MEMORANDUM

CITY & BOROUGH OF JUNEAU

FILE NO.: USE2002-00043 - Conditional Use

PROPOSAL: A Conditional Use permit for a new 15,750 square foot two-story building with office space

1 SITE PLAN

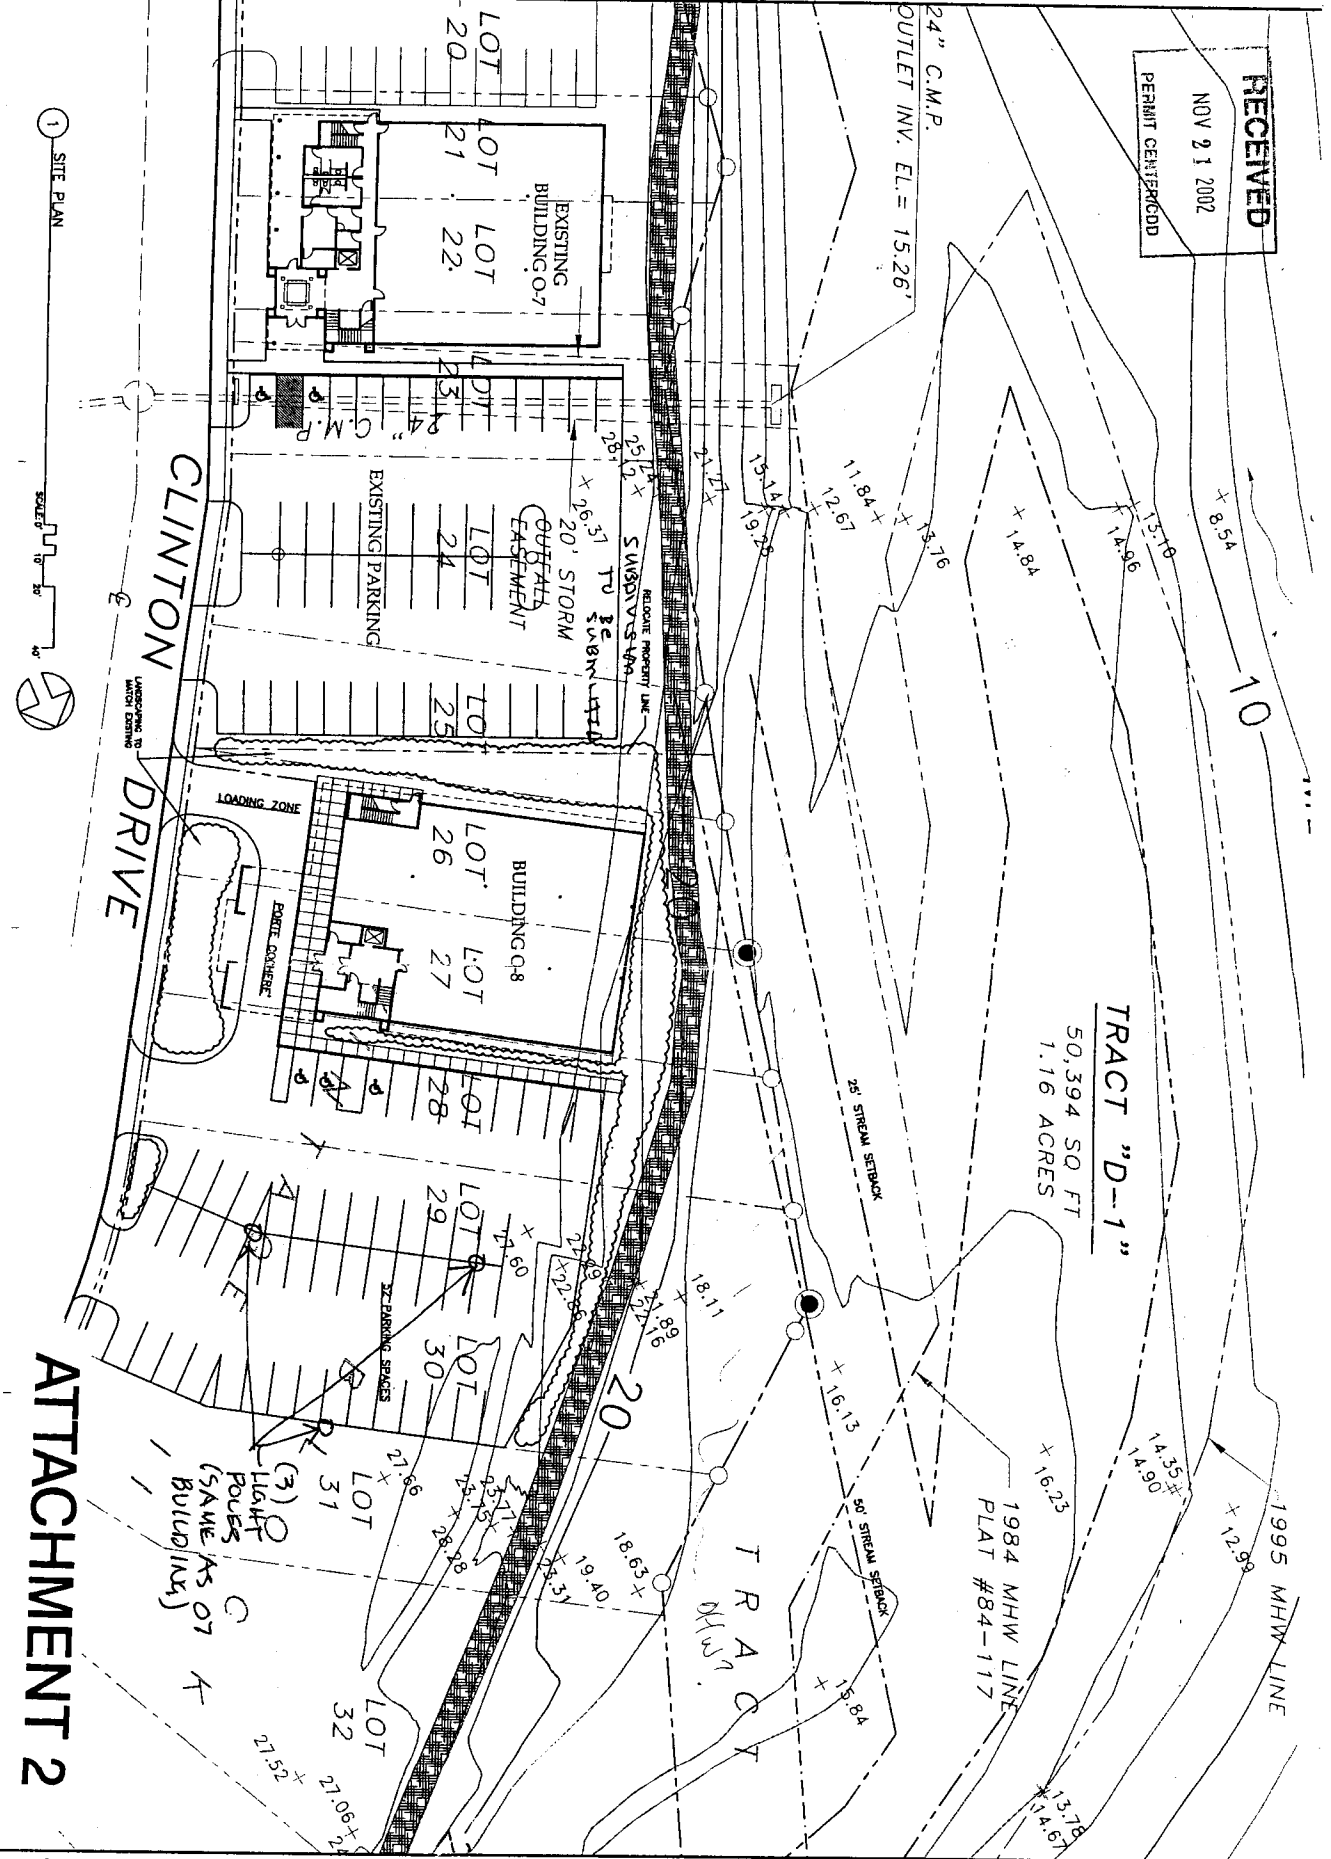
The applicant has provided 52 parking spaces, including 3 accessible spaces, plus a loading zone. The porte cochere at the main entry will accommodate up to two vehicles for drop-off. The parking standard for offices without customer service is 1 space per 300 square feet of gross floor area. This results in a parking requirement of 52 spaces, which the applicant has met (Attachment 2).

The applicant has indicated that the proposed project is located 100 to 180 feet from the ordinary high water mark of the Mendenhall River, as noted in the applicant's letter and site plan (Attachments 2 and 6). Based on site visits, CDD staff has determined that the ordinary high water mark is approximately seven feet from the bike path in many places, which makes the proposed project 50 to 80 feet from the mark. In short, staff has concluded that the ordinary high water mark, and thus the start of the 50-foot buffer, is at the point that the applicant considers the end of the 50-foot buffer.

CDD staff has discussed this issue with the applicant at the pre-application meeting and in subsequent phone conversations. We agree that there is a disagreement, and we have also agreed to set aside that disagreement in the review of this current allowable use permit, since the development as proposed is outside of the 50-foot setback even when CDD's determination of the OHW mark is used. Future Vintage Park proposals that are closer to the river will require a firm resolution of the OHW mark disagreement.
